Access Compliance Report Public Rights-of-Way (Curb Ramps)

Main Street: WEMBLEY_RD Cross Street: ENGEL_DR Location: NE

ADA ID: RPRK211216120135 Ramp Type: Type 1 - Perpendicular Diagonal Initial Pass/Fail: Pass Overall Compliance: No Severity Score: 10

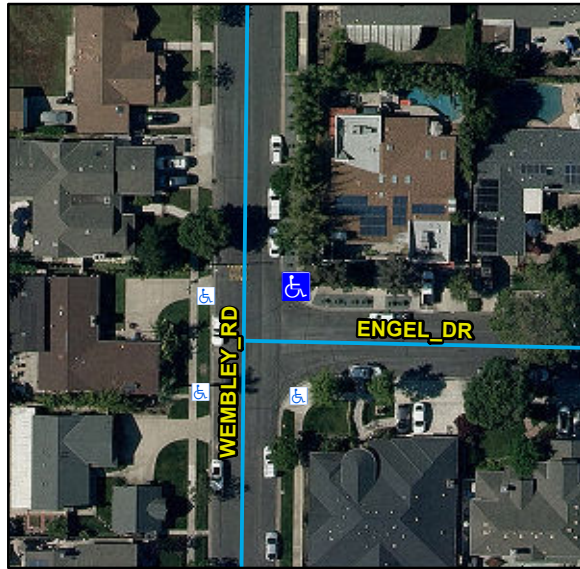
Compliance	Description	Data	Compliance	Description	Data
N/A	Ramp Length (in)	84	N/A	Flare Type LT	
Yes	Ramp Width (in)	54			Sloped
Yes	Ramp Run Slope (%)	7.8	N/A	Flare Slope LT (%)	7.1
Yes	Ramp Cross Slope (%)	0.3	N/A	Flare Traversable LT	No
N/A	Landing Present	Yes	N/A	Flare Type RT	
N/A	Landing Length (in)	49			Sloped
Yes	Landing Width (in)	48	N/A	Flare Slope RT (%)	3.2
No	Landing Run Slope (%)	2.1	N/A	Flare Traversable RT	No
Yes	Landing Cross Slope (%)	0.7	No	DWS Provided	No
N/A	Landing Movement Obstructed?	No	N/A	DWS Contrast	N/A
	Landing Movement Type	N/A	N/A	DWS Length (in)	N/A
N/A	Landing Shared	No	N/A	DWS Full Width	N/A
N/A	Clear Space	Yes	N/A	DWS Offset Left (in)	N/A
N/A	Clear Space To Crosswalk (in)	48	N/A	DWS Offset Right (in)	N/A
N/A	Marked Crosswalk 1	No	N/A	Marked Crosswalk 2	No
	Crossing 1 Direction	W		Crossing 2 Direction	S
	Marked Crosswalk 1 Width (in)	N/A		Marked Crosswalk 2 Width (in)	N/A

N/A	Ramp Inside Crosswalk 1	N/A	Yes	Ramp Inside Crosswalk 2	N/A
	Crossing 1 Slope (%)	8.1		Crossing 2 Slope (%)	6.9
	Crossing 1 Cross Slope (%)	3.7		Crossing 2 Cross Slope (%)	0.4
No	Gutter Ponding	Yes	No	Curb Slope	6.3
Yes	Gutter Lip Height (in)	0		Road Run Slope (%)	2.3
Yes	Gutter Run Slope (%)	4.9		Road Cross Slope (%)	9.3
Yes	Gutter Cross Slope (%)	0.7			
Yes	Overall Surface Condition: Acceptable		No	Perp Joint Present	No
	Cross Gutter Present?	No		Spandrel Present?	No
	Replace Cross Gutter?	N/A		Replace Spandrel?	N/A

Remove & Replace Curb Ramp With Two New Directional Ramps or Equivalent.
